ADDENDUM NO. 1

LIBERTY AND WESTCHESTER INTERMEDIATE SCHOOLS - ATHLETIC SITE PROJECTS Chesterton, IN 46304

ADDENDUM ONE

Addendum One (AD.01) to the drawings and specifications prepared by Gibraltar Design for **Liberty and Westchester Intermediate Schools Athletic Site Projects** for Duneland School Corporation, Chesterton, Indiana.

LIS P-002

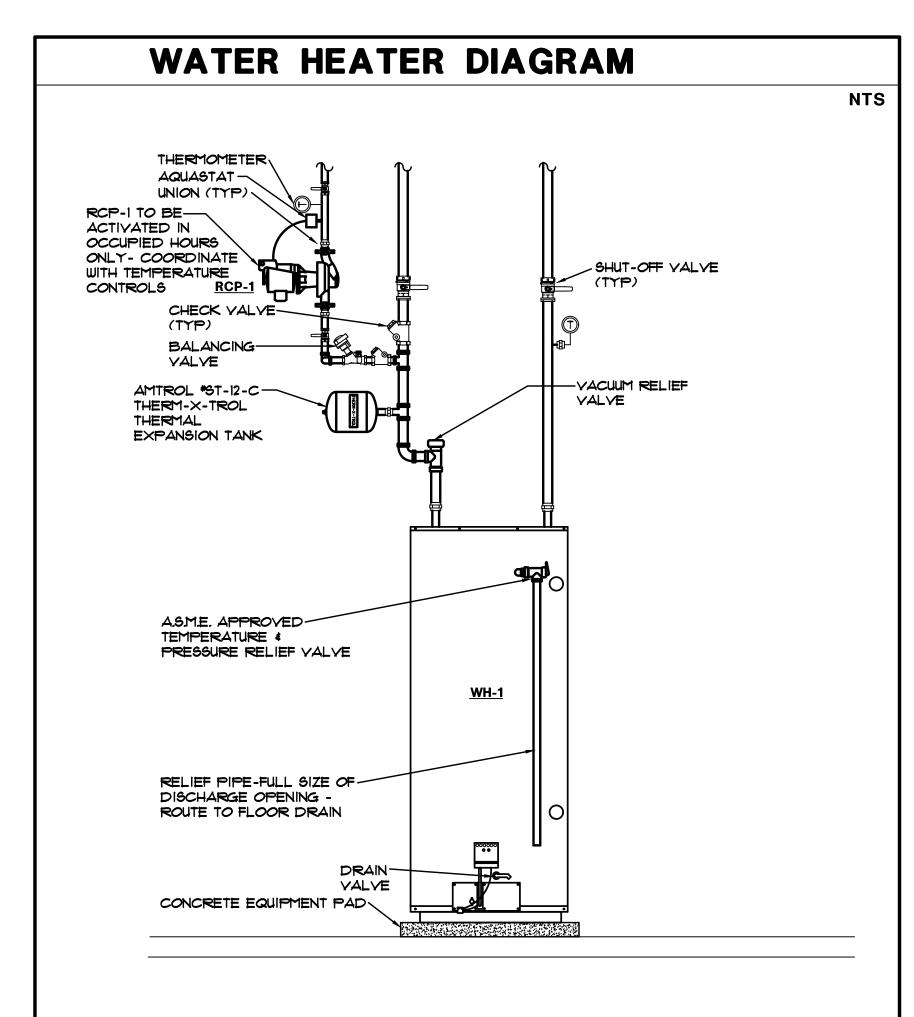
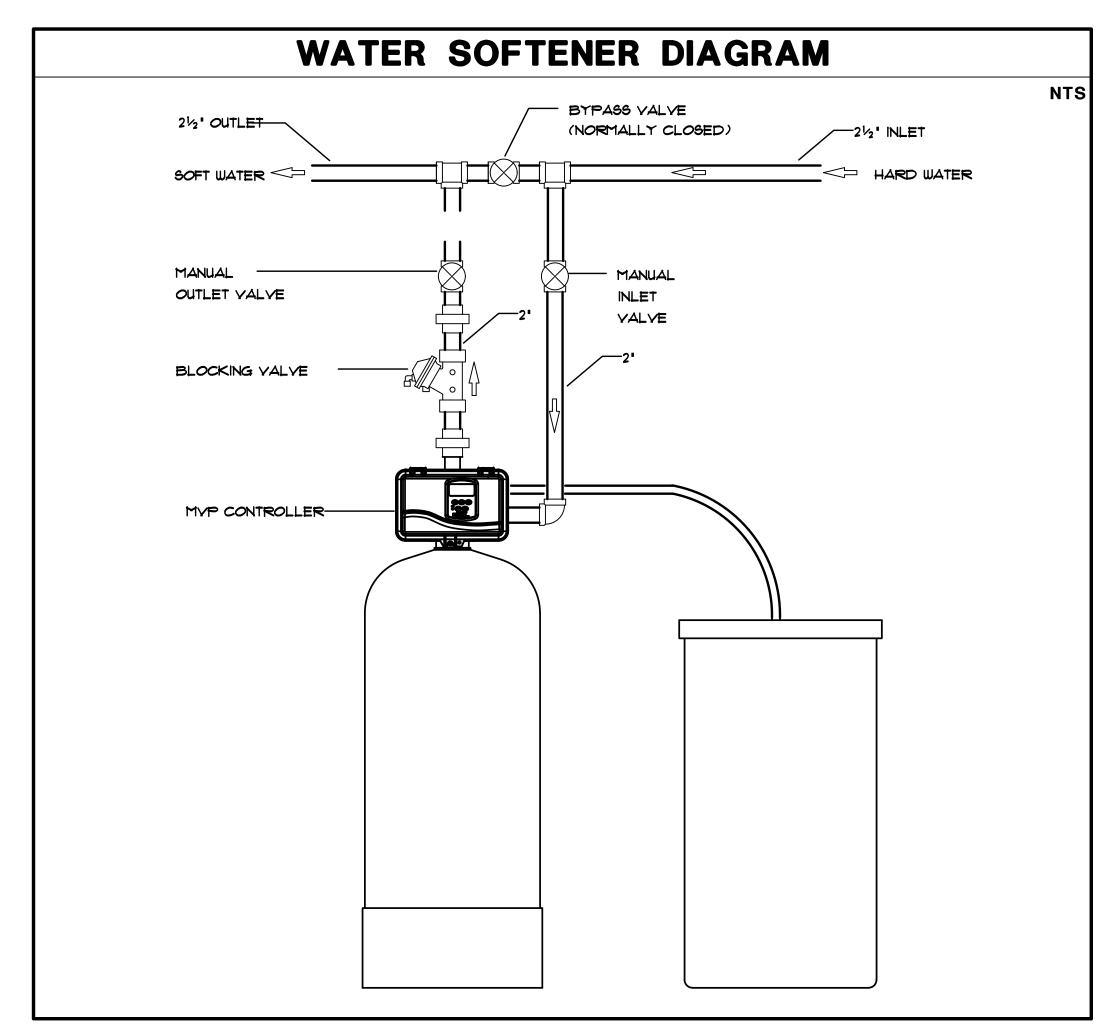
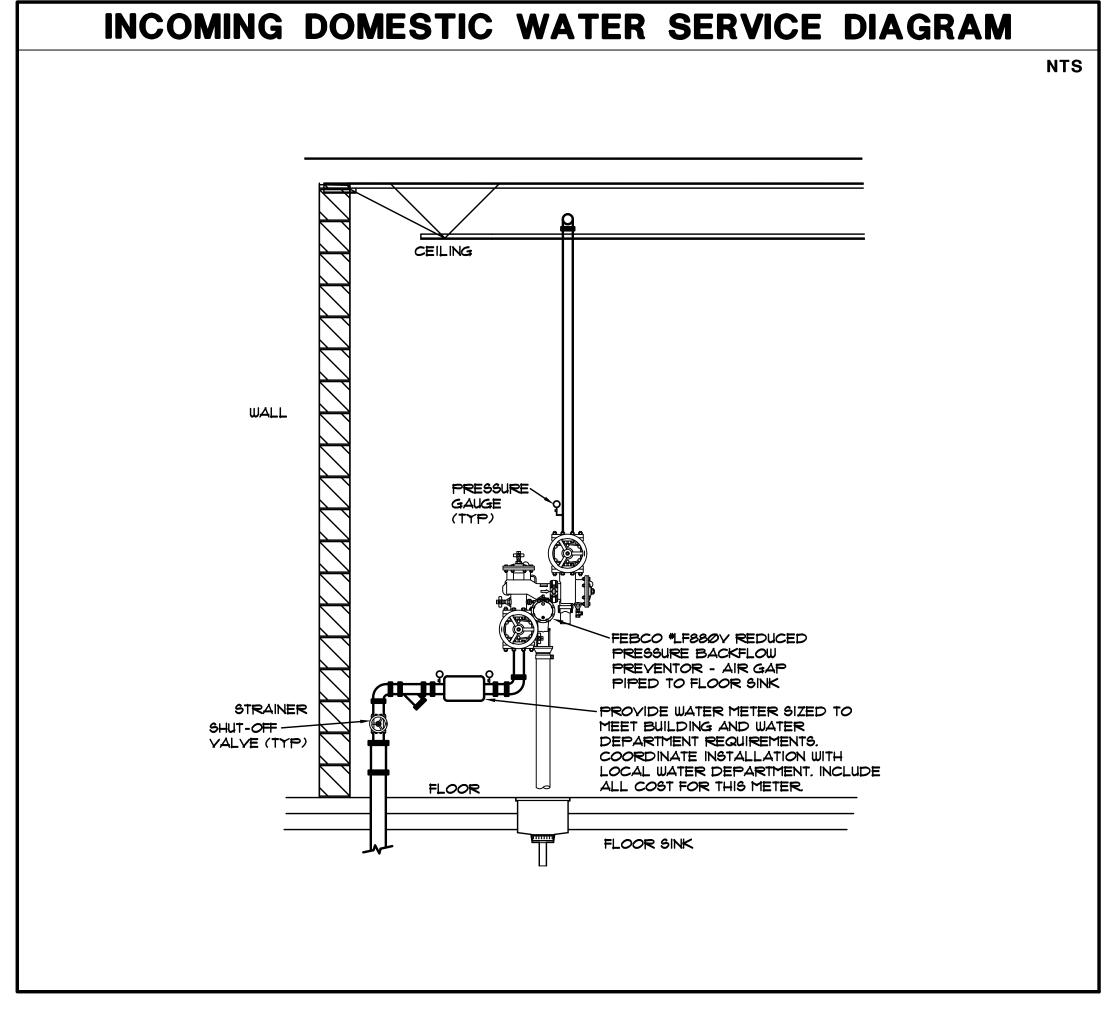
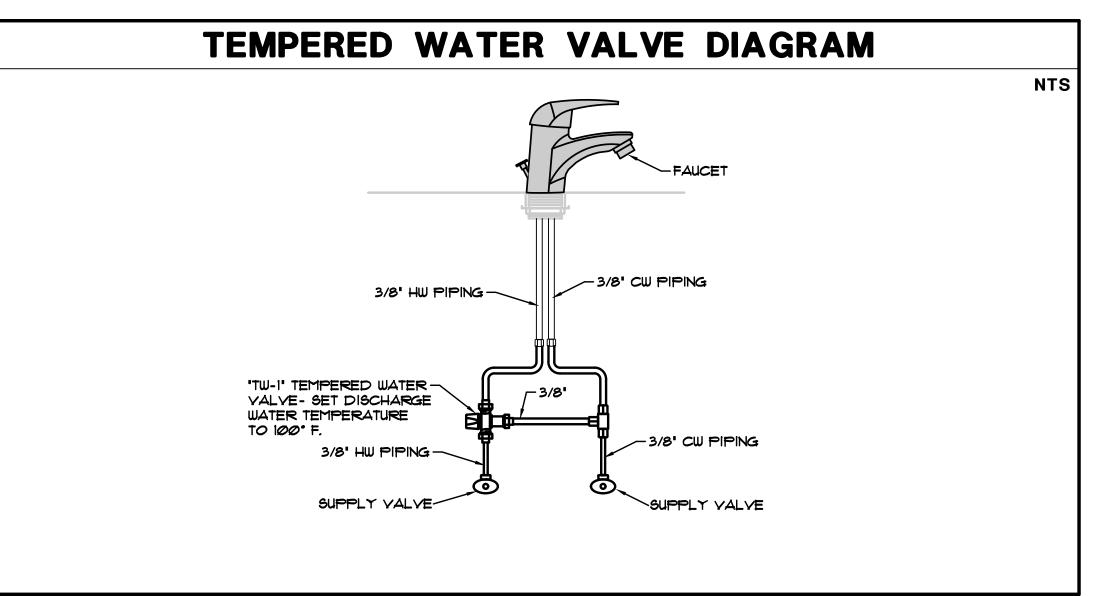
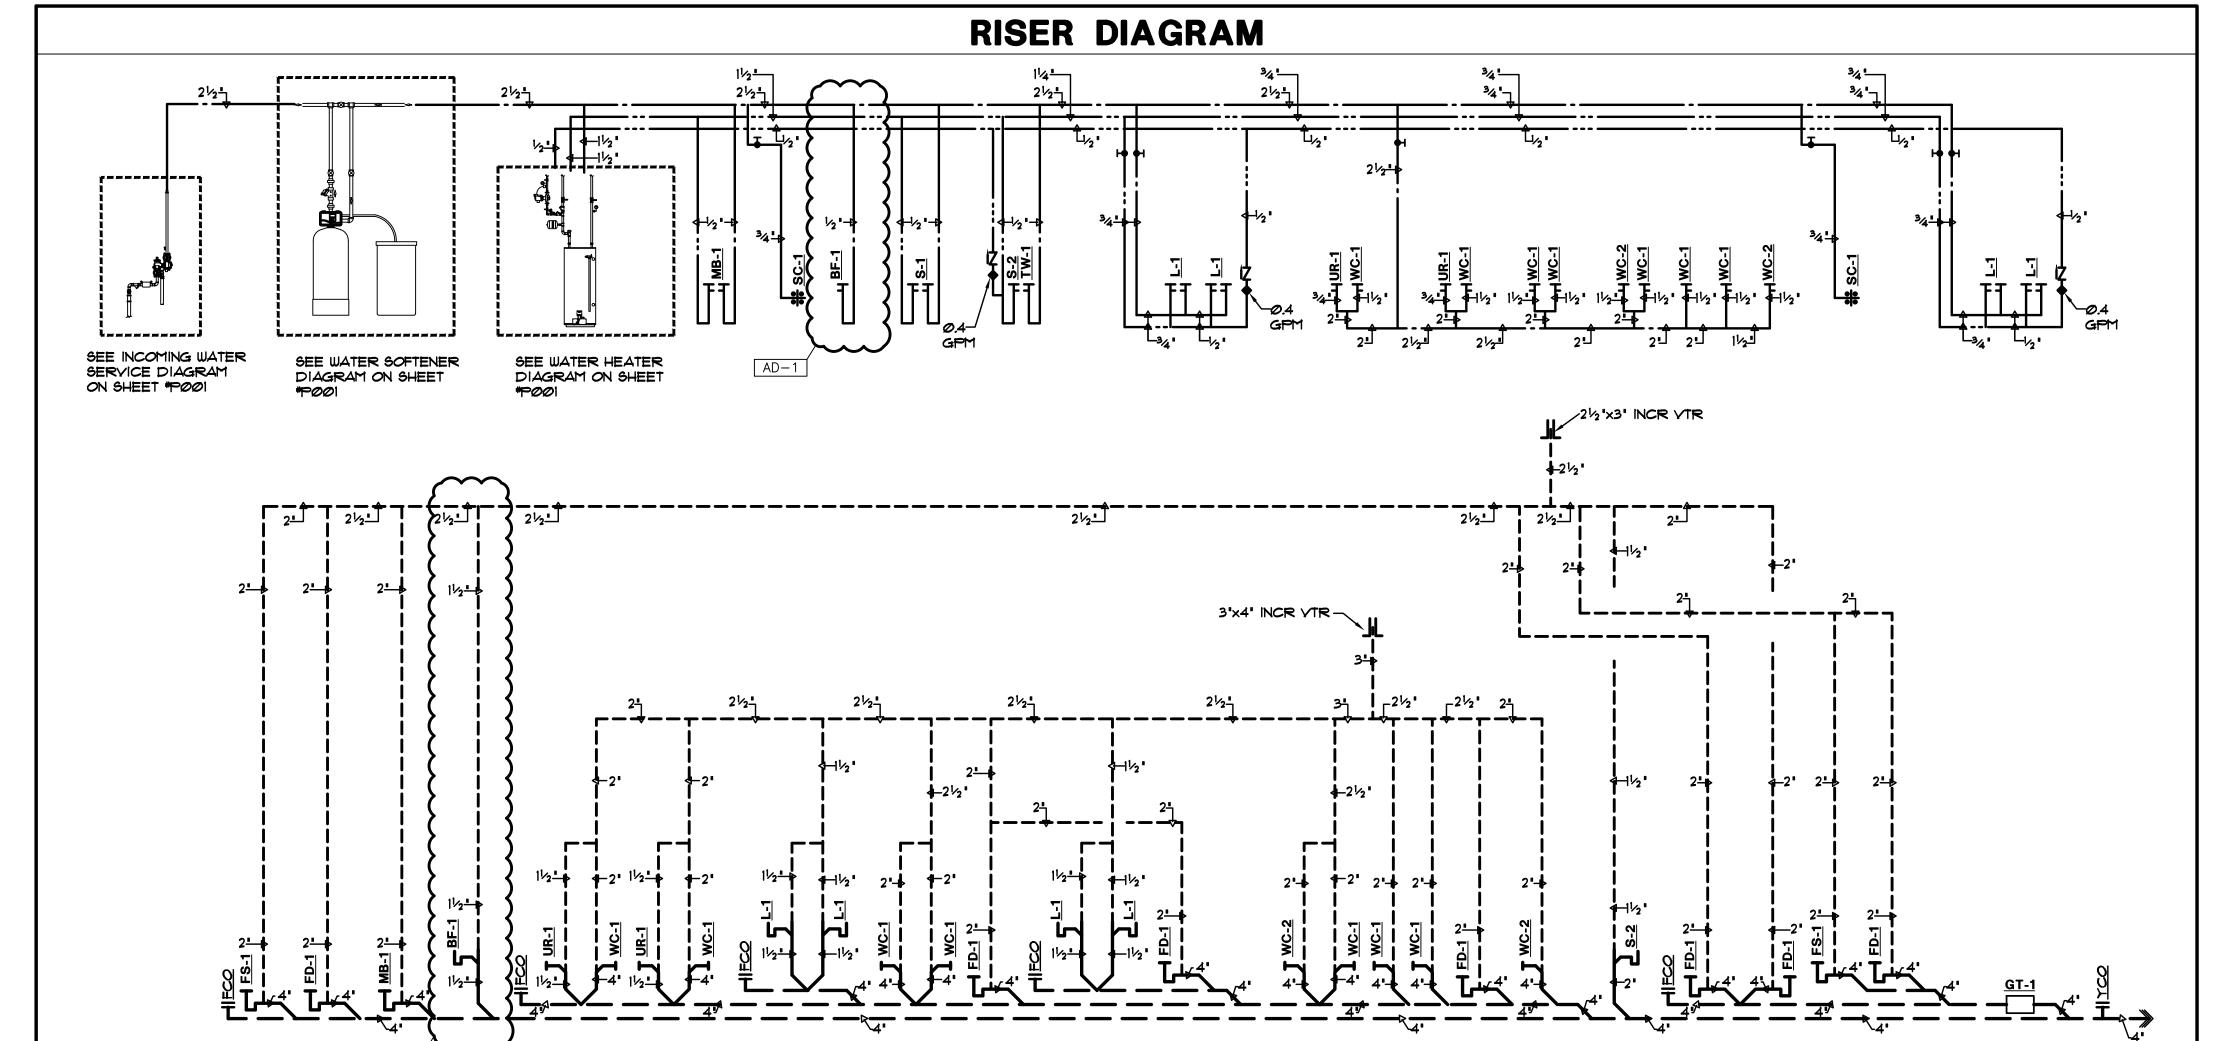
8. Sheets P-002 and P-004

A. Refer to two (2) revised full-size drawings, included in this Addendum, for revised Plumbing Riser Diagram.

WIS P-003

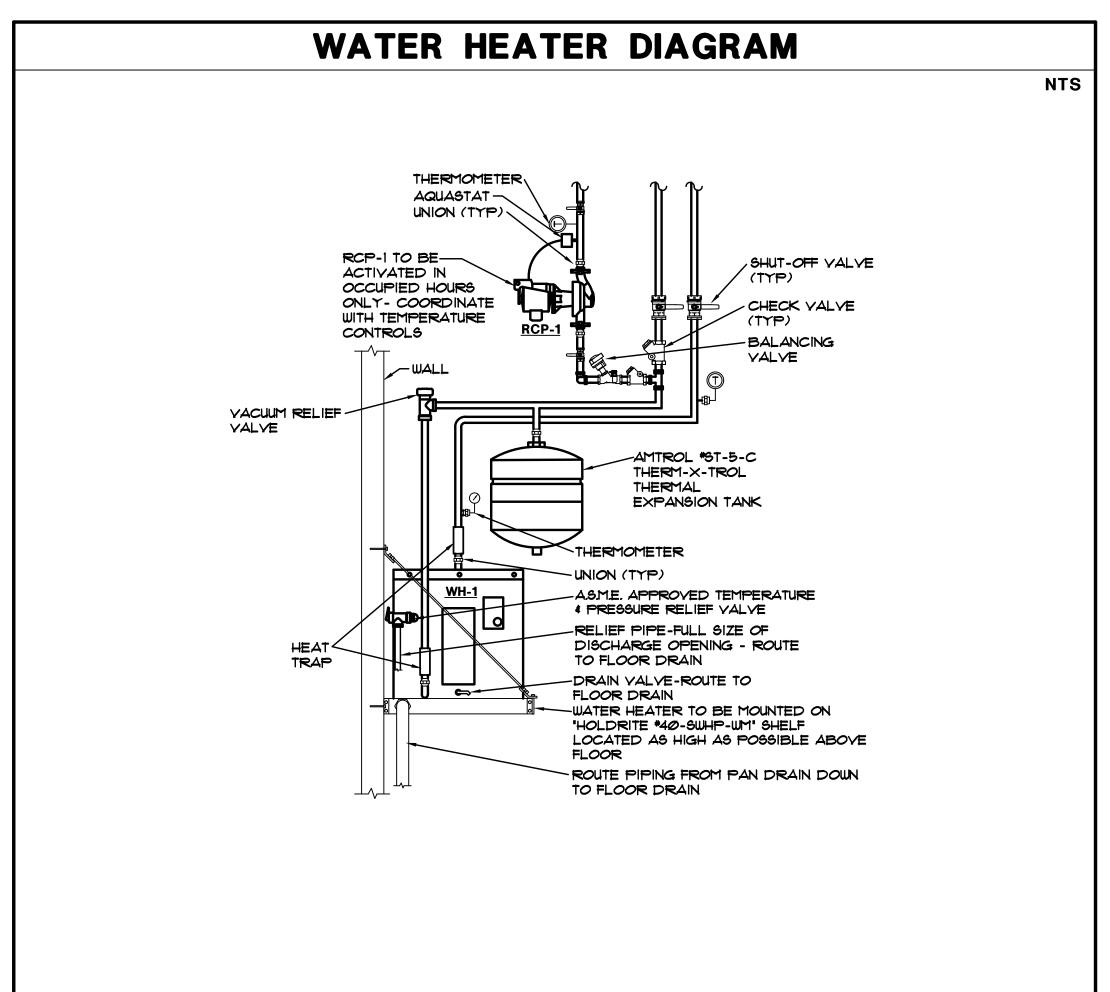
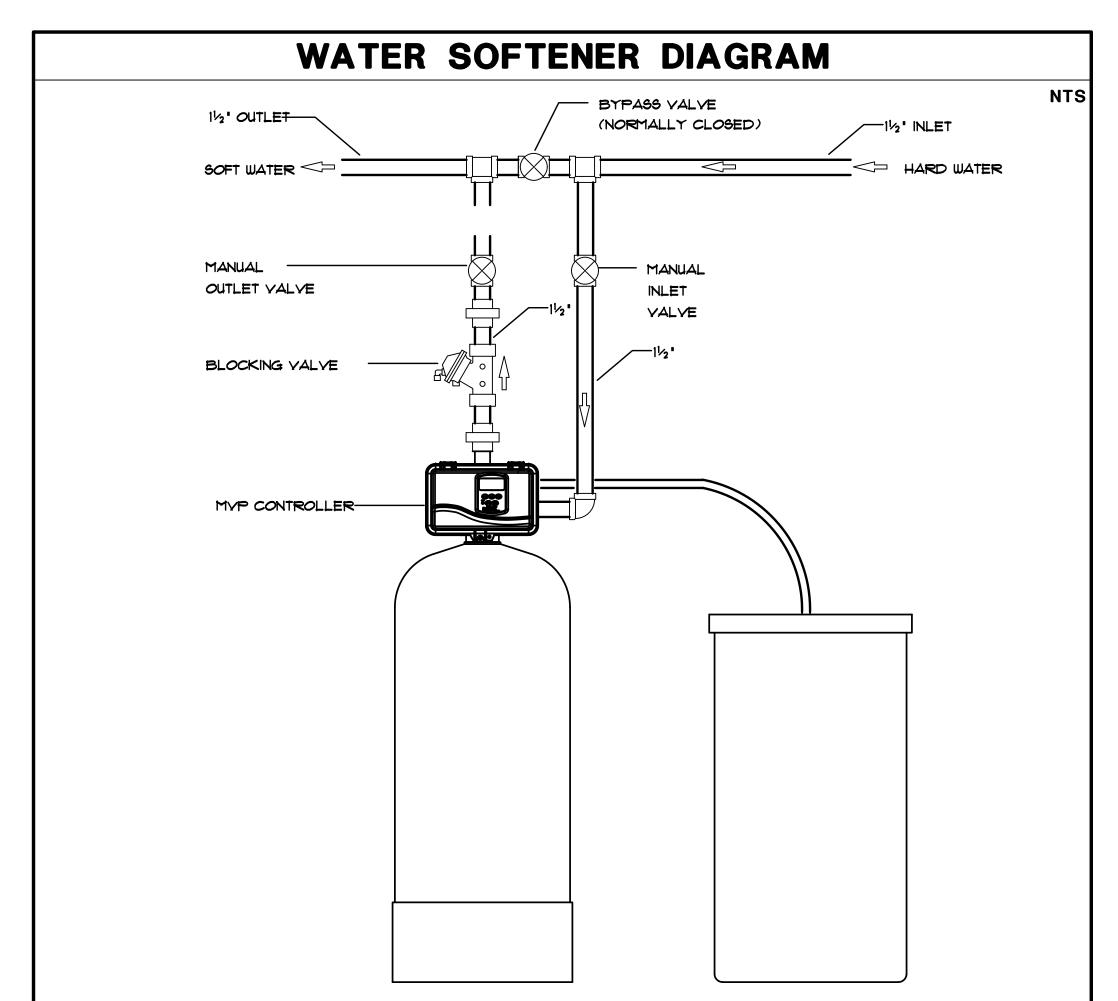
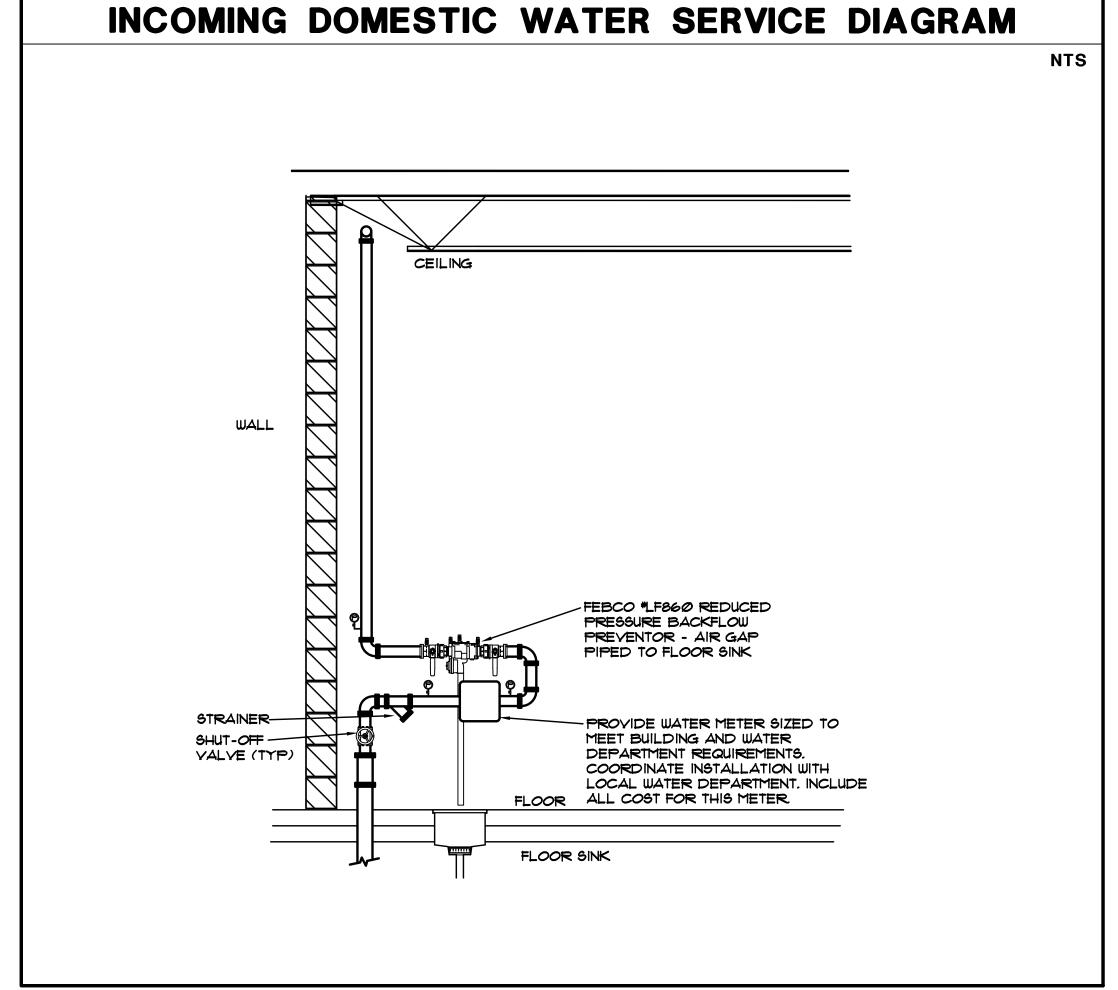
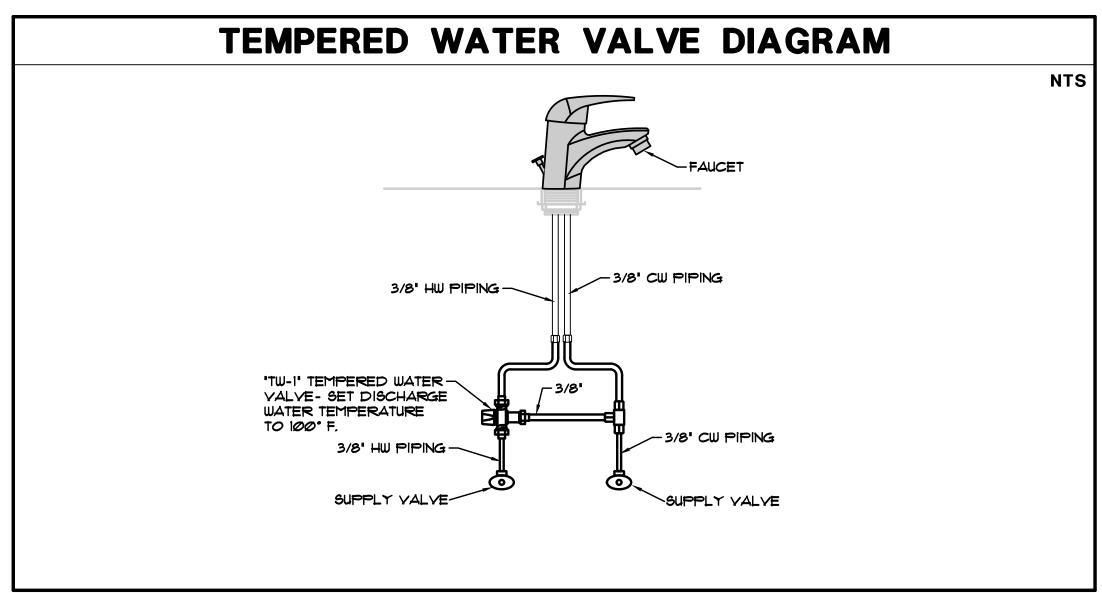
7. Sheet P-001 and P-003

A. Refer to two (2) revised full-size drawings, included in this Addendum, for revised Plumbing Equipment and Fixture Schedule.
